Subject: Duke Power Company LLC
Oconee Nuclear Station, Unit 3
Docket Nos. 50-287
Third Ten Year Inservice Inspection Interval
Request for Relief No. 05-ON-002, Rev 1

Request for Additional Information
With Response Re:

TECHNICAL LETTER REPORT
REQUEST FOR ADDITIONAL INFORMATION
ON THIRD 10-YEAR INSERVICE INSPECTION INTERVAL
REQUEST FOR RELIEF 05-ON-002
FOR
DUKE POWER COMPANY
OCONEE NUCLEAR STATION, UNIT 3
DOCKET NUMBER 50-287

05-ON-002
Revision 1

(W4)
3-RPV-WR34
B01.011.004

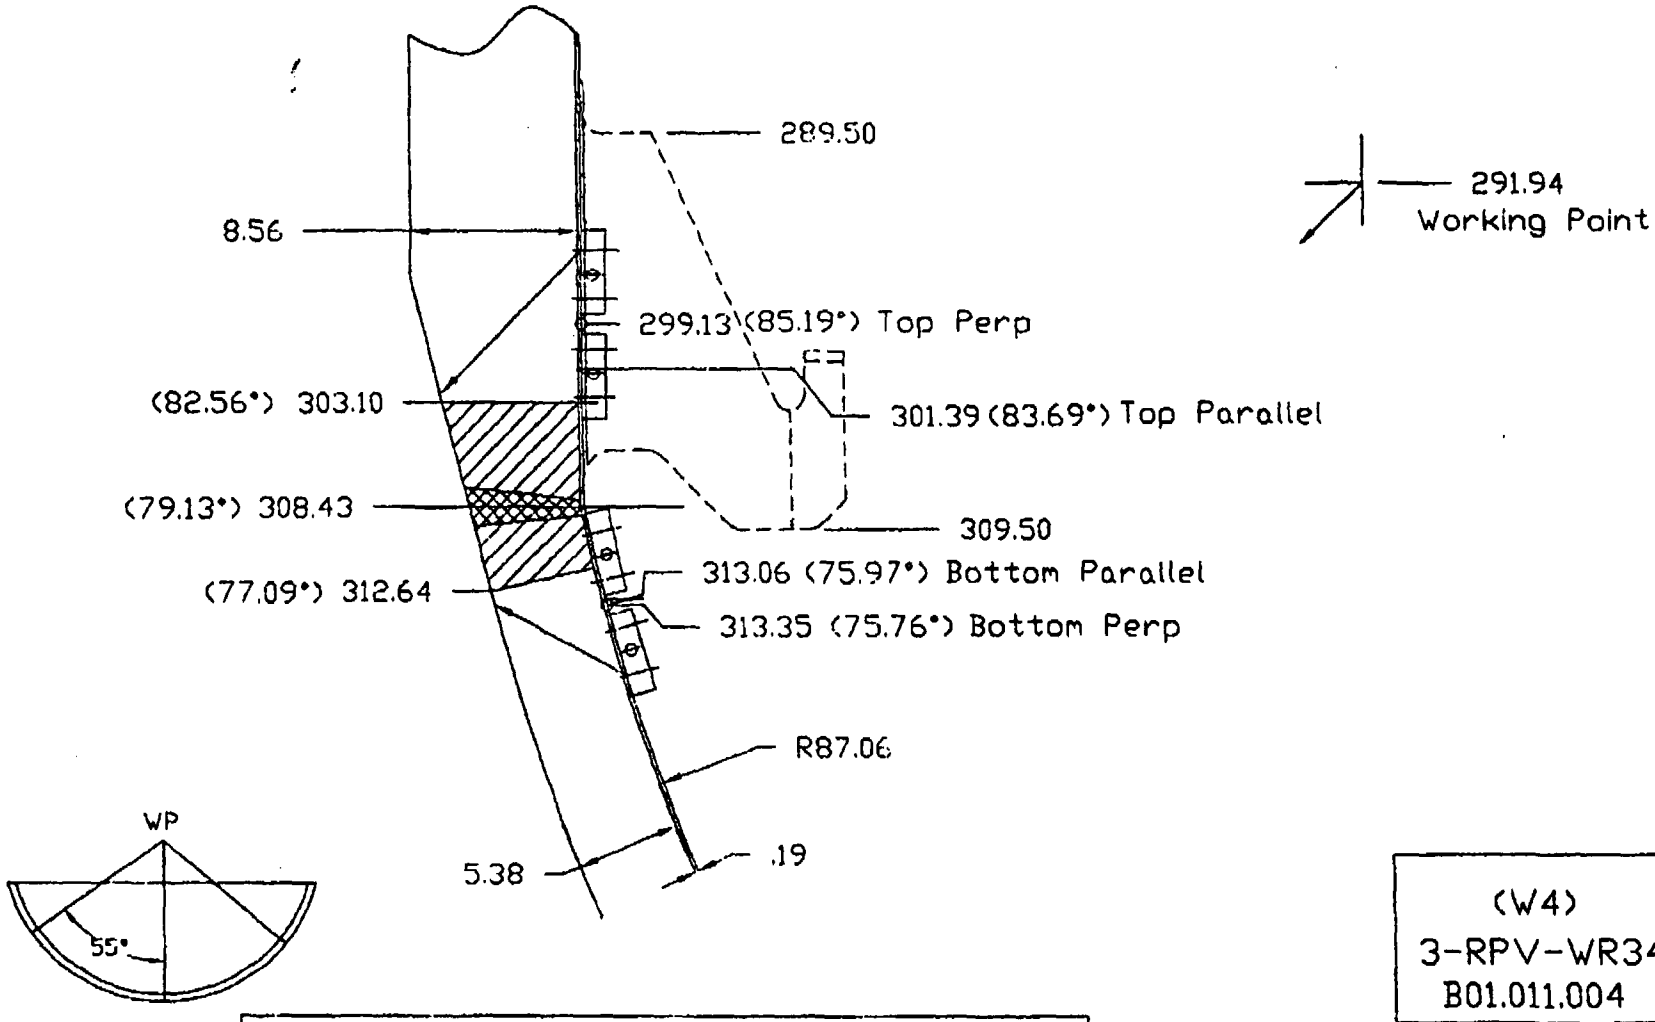
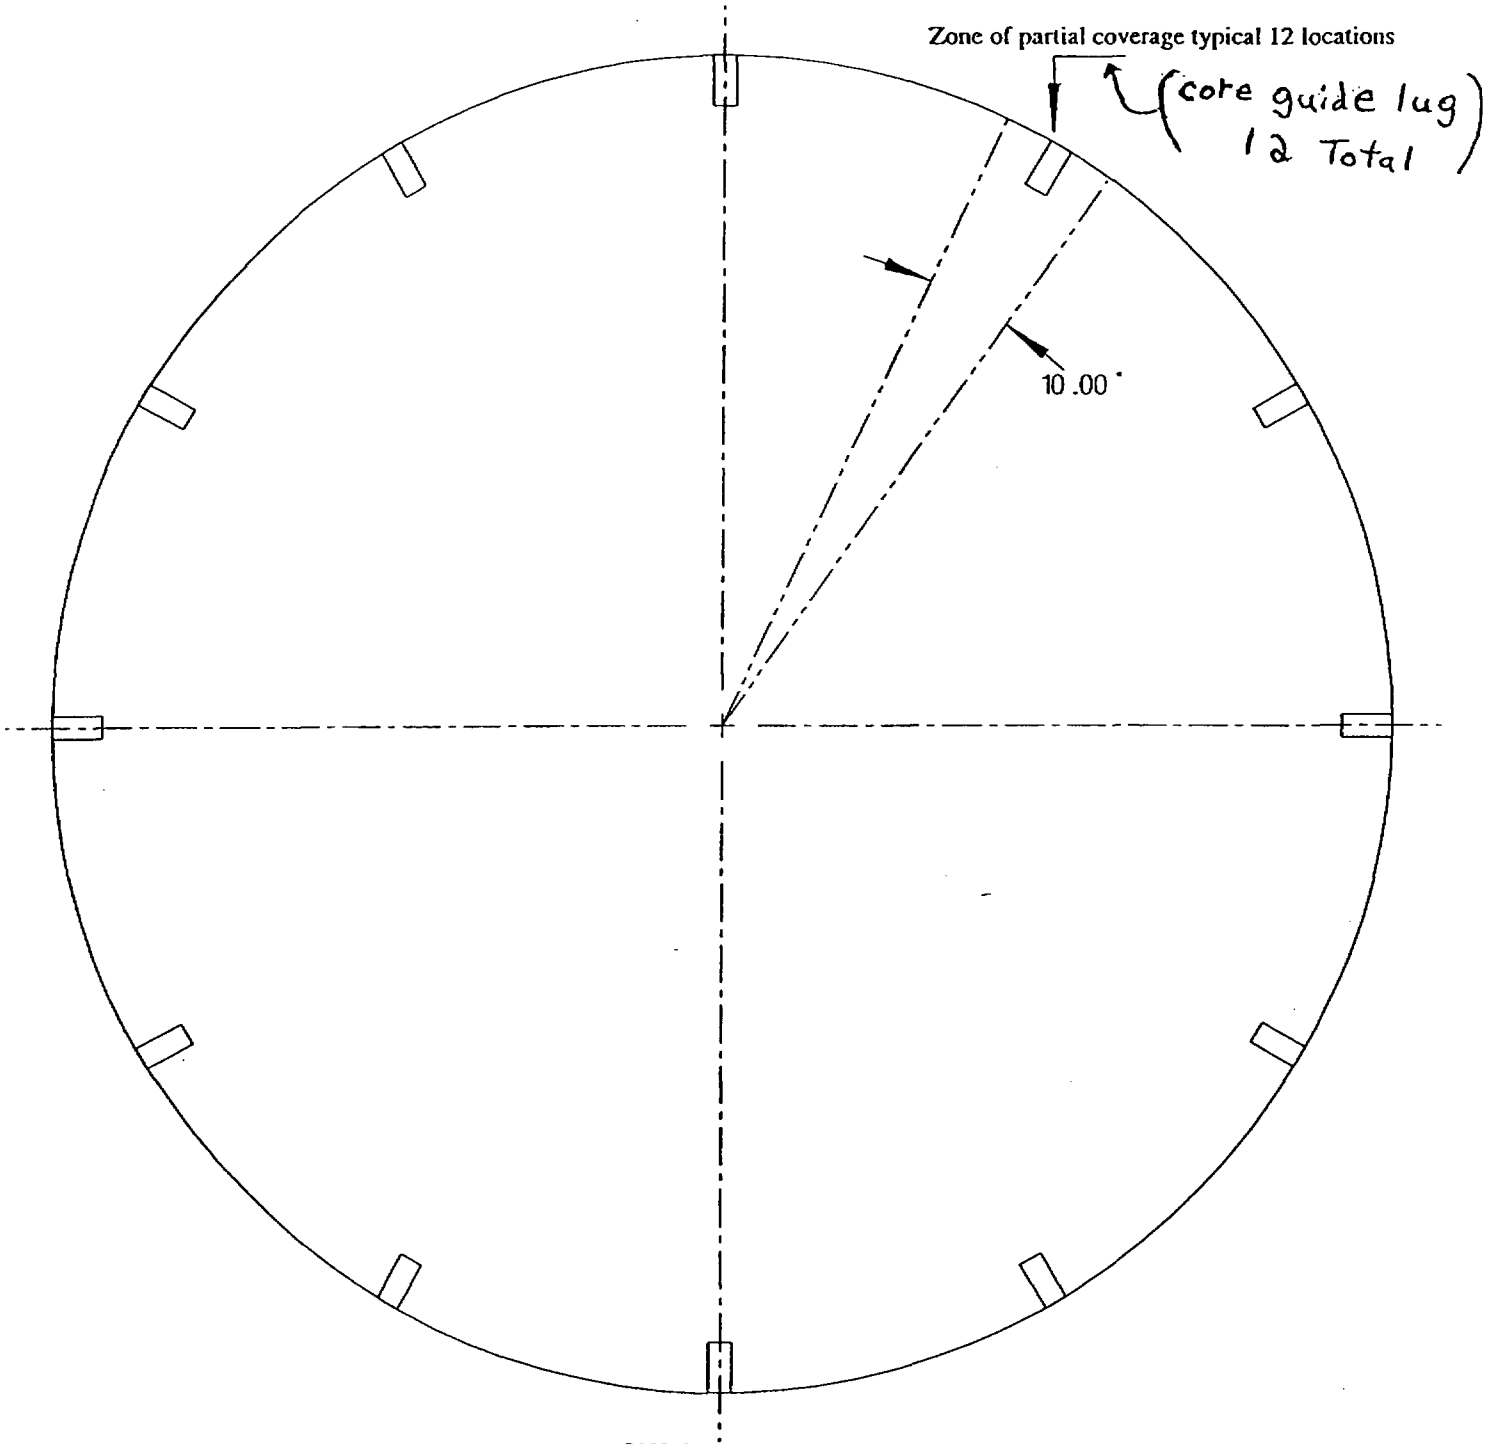
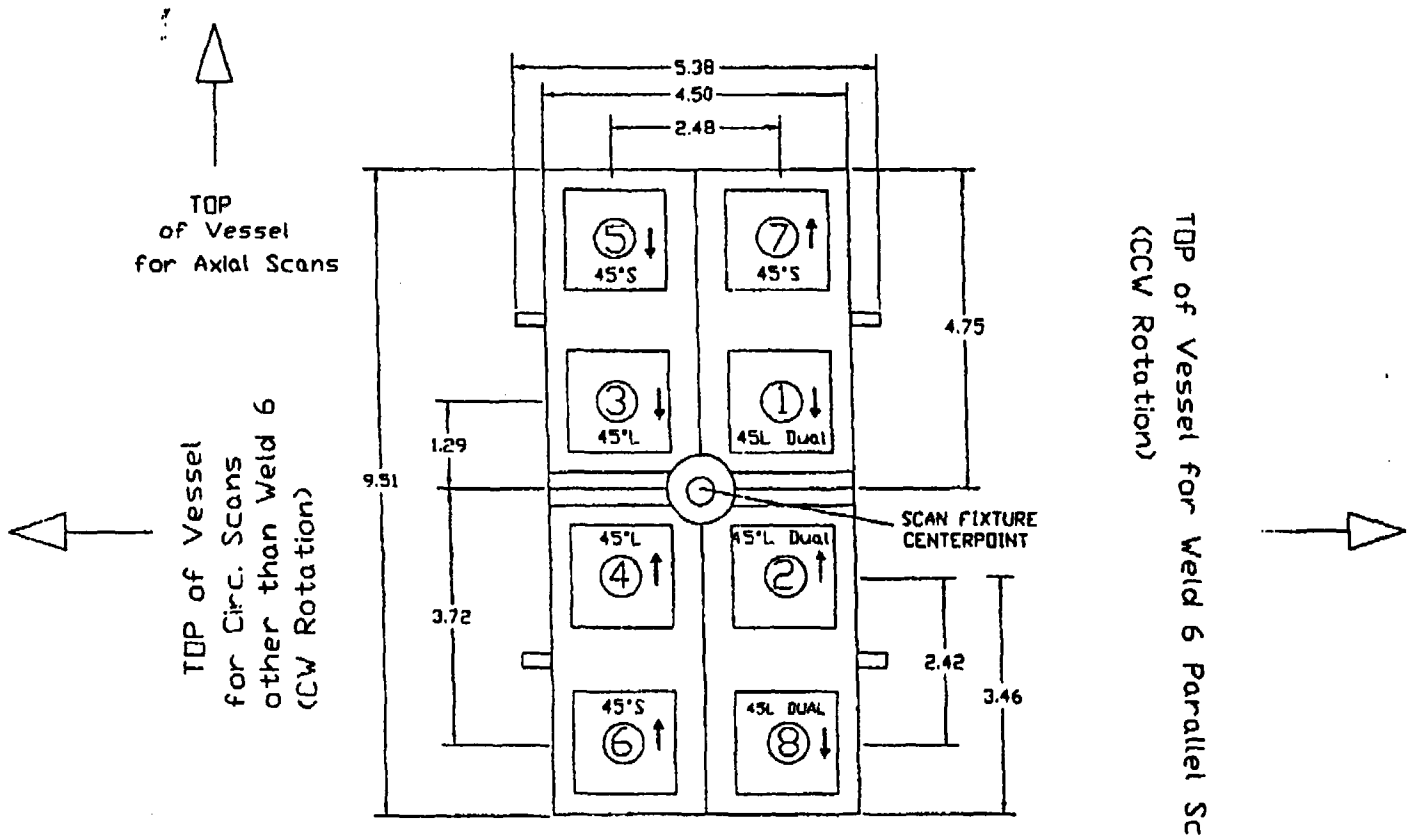
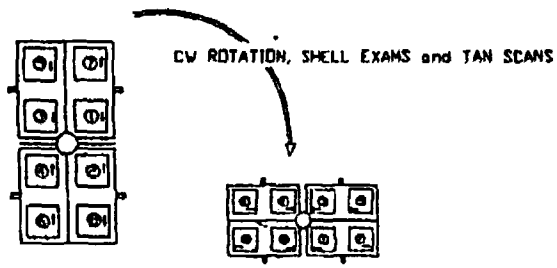
2.2(a) For RPV shell-to-lower head Weld 3-RPV-WR34, the licensee stated that core support/guide lugs caused restrictions to the scanning access for these welds. Please be more specific as to how the RPV appurtenances restrict scanning access. Describe the remote UT fixture, including the transducer sled dimensions, and how the guide lugs prevented placing the transducer sled in a proper position for performing the examinations. Provide similar information for lower head ring Weld 3-RPV-WR35.

For weld 3-RPV-WR34:
Pages 2 of 4 and 4 of 4 were added to attachment B that should help to answer the question.
(note: Page 2 of 4 should have been sent with the original request for relief but may have been lost during the transmittal process. Page 4 of 4 is a new page.)

During ultrasonic examination, 100% coverage of the required examination volume could not be obtained. Twelve core guide lugs restrict the scanning surface, as shown on the Attachment B drawing, causing limitations that resulted in 44.5% coverage. The percentage of coverage reported represents the aggregate coverage from all scans parallel and perpendicular to the weld. The weld and adjacent base material were examined using 45° refracted shear waves and 45° refracted longitudinal waves. Examination volumes directly below the core guide lugs received no coverage when scanned parallel to the weld. Additionally no scans were performed perpendicular to the weld directly below the core guide lugs. Scans parallel to the weld were restricted to 7.6 inches on either side of each core guide lug and scans perpendicular to the weld were restricted to 4.7 inches on either side of each core guide lug. In order to achieve more coverage, the core guide lugs would have to be moved to allow greater access, which is impractical. There were no recordable indications found in the areas that were examined.

(W1)
3-RPV-WR19
B01.030.001

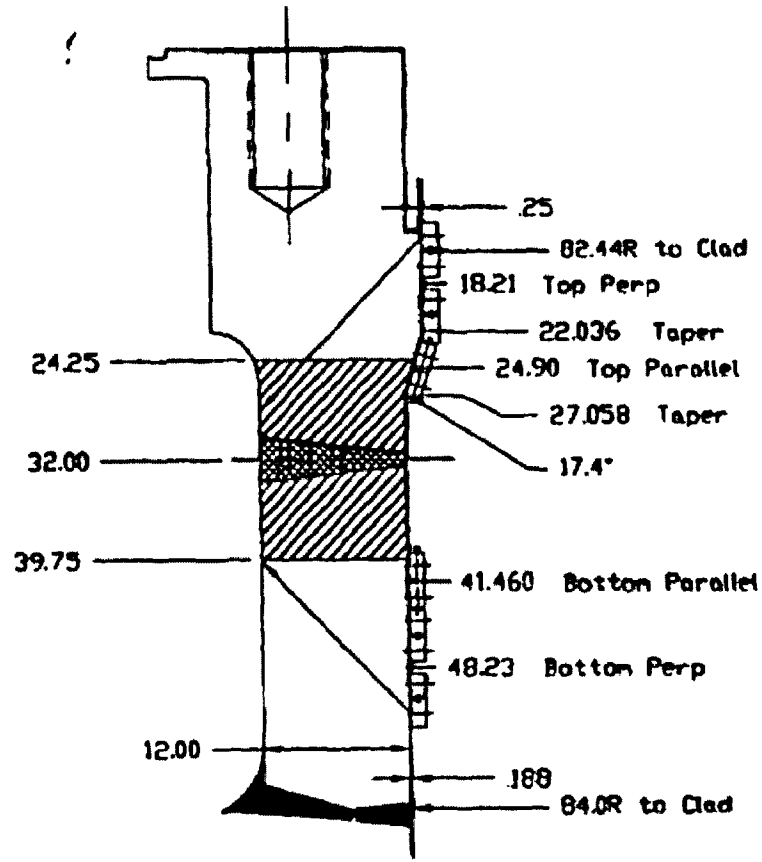
However, Weld 3-RPV-WR19 is a shell-to-flange weld, and is specifically excluded, by Article I-2000, from the requirements of Appendix VIII. This weld must be examined using the procedures, personnel and equipment requirements listed in ASME Code Section V, Article 4, as supplemented by ASME Code Section XI, Article I.

While the NRC would like to encourage the use of performance-demonstrated UT methods for components not currently within the scope of Appendix VIII, the actual ASME Code requirement for Weld 3-RPV-WR19 at Oconee 3 is to use Article 4 of ASME Section V, supplemented by Article I of ASME Section XI. The licensee has not met this requirement, and therefore, must propose an alternative, in accordance with 10 CFR 50.55a(a)(3)(I), to use personnel, equipment and procedures qualified in accordance with ASME Section XI, Appendix VIII, Supplements 4 and 6, 1995 Edition with the 1996 Addenda, for Weld 3-RPV-WR19.

Duke submitted Relief 04-GO-002 on 7-14-2004, which was approved by the NRC by letter of 10-20-2004. This was a proposed alternative to use personnel, equipment and procedures qualified in accordance with ASME Section XI, Appendix VIII, Supplements 4 and 6, 1995 Edition with the 1996 Addenda, for several welds, including Weld 3-RPV-WR19.

During ultrasonic examination, 100% coverage of the required examination volume could not be obtained. The examination coverage was limited to 85.8%. The percentage of coverage reported represents the aggregate coverage from all scans parallel and perpendicular to the weld. Limitations were caused by inside surface taper and the ledge shown in Attachment D. The percentage of coverage reported represents the aggregate coverage from all scans. The weld and adjacent base material were examined using 45° refracted shear waves and 45° refracted longitudinal waves. There were no recordable indications found in the areas that were examined. In order to achieve more coverage, the weld would have to be redesigned which is impractical.
(See Attachment D for exam information)

Core Flood Nozzle to Shell @ 0° - 3RPV-WR54 (B03.090.007)
Core Flood Nozzle to Shell @ 180° - 3RPV-WR54A (B03.090.008)

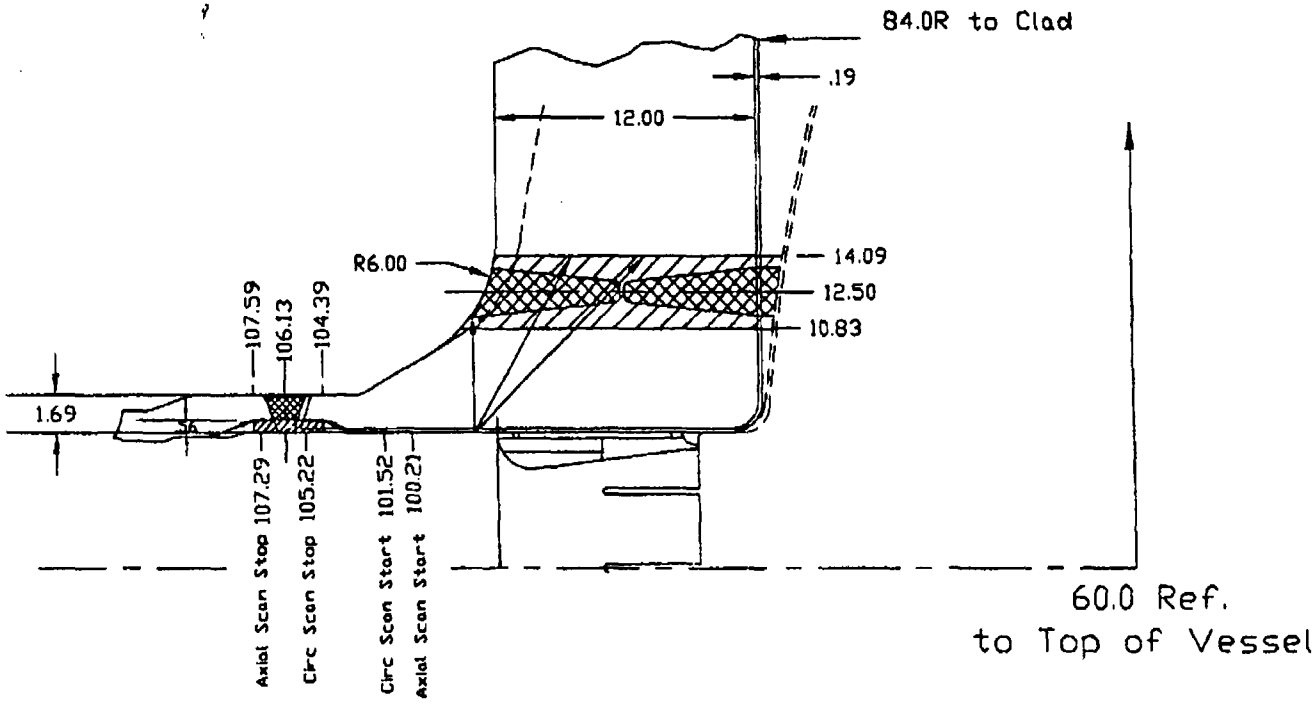
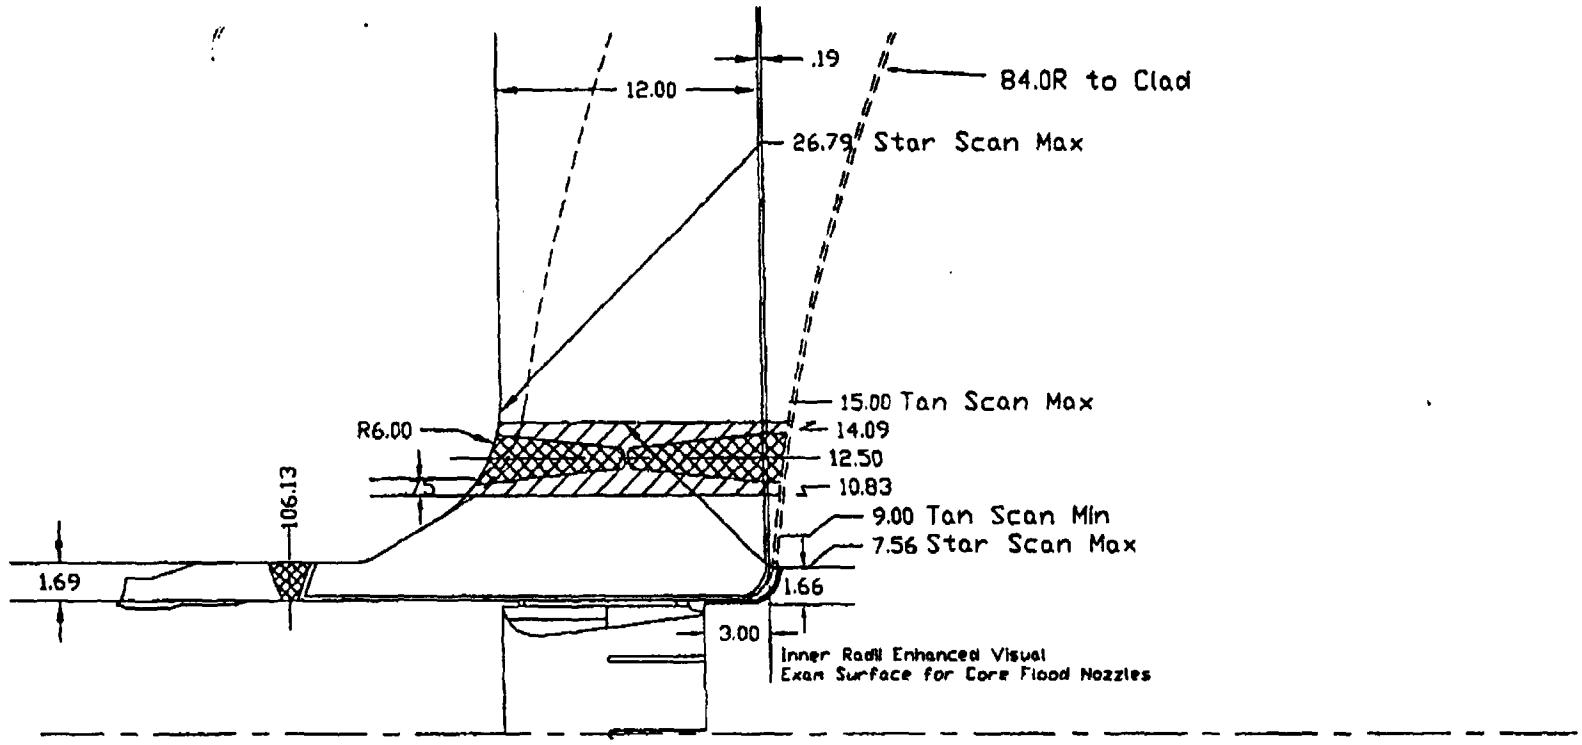
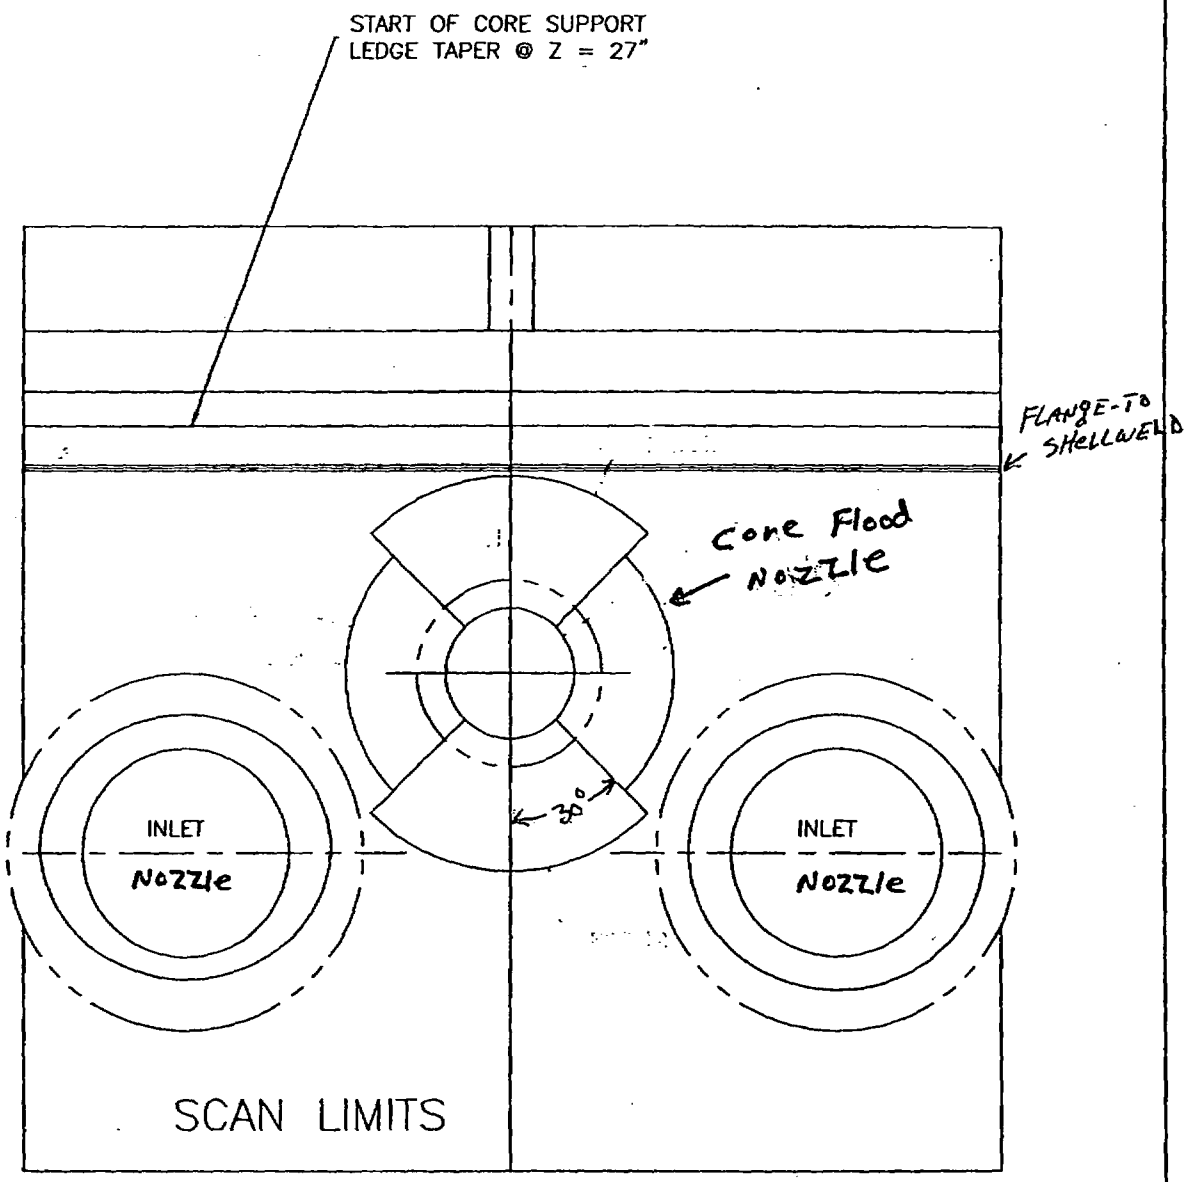
2.3(a) These nozzle-to-vessel welds are on core flood nozzles located at 0 and 180 degrees on the RPV. The licensee stated that these examinations were performed during December 2004, and that examination of nozzle-to-vessel Welds 3-RPV-WR54 and -WR45A were conducted using personnel, procedures and equipment qualified in accordance with ASME Section XI, Appendix I, 1989 Edition, with no Addenda.

However, 10 CFR 50.55a(g)(6)(ii)(C) requires licensees to implement the 1995 Edition, with 1996 Addenda, of ASME Section XI, Appendix VIII, Supplements 5 and 7, for RPV nozzle-to-vessel welds examined after November 22, 2002. These Supplements list the requirements for performance demonstration of procedures, personnel and equipment. The licensee should clarify whether the stated UT qualifications

were mistakenly identified or explain why the examination of Welds 3-RPV-WR54 and -WR54A were not performed using personnel, procedures and equipment qualified under Supplements 5 and 7, as required by CFR.

The wrong reference was used. Paragraph H of the Original Relief Request will be revised to read as shown below:

> Ultrasonic examination of areas/welds for item numbers B03.090 were conducted using personnel, equipment and procedures qualified in accordance with ASME Section XI, Appendix VIII, Supplements 4, 6, & 7, 1995 Edition with the 1996 Addenda. Although limited scanning prevented 100% coverage of the examination volume, the amount of coverage obtained for these examinations provides an acceptable level of quality and integrity. (See Paragraph I for additional justification.)

Note: Supplement 5 was not used to examine the nozzle inside radius because an enhanced visual examination was performed in lieu of UT examination per Code Case N-648-1.

During ultrasonic examination, 100% coverage of the required examination volume could not be obtained. The examination coverage was limited to 84.2% of the required volume. The Core Flood Nozzles of a B&W 177 plant have several obstructions which limit ultrasonic examination coverage. In order of significance these are:

- The flow restrictor which is welded to the inner bore of the nozzle;
- The inlet nozzles located 30° on either side of each core flood nozzle;
- The taper above the core flood nozzles associated with the Core Support Ledge.
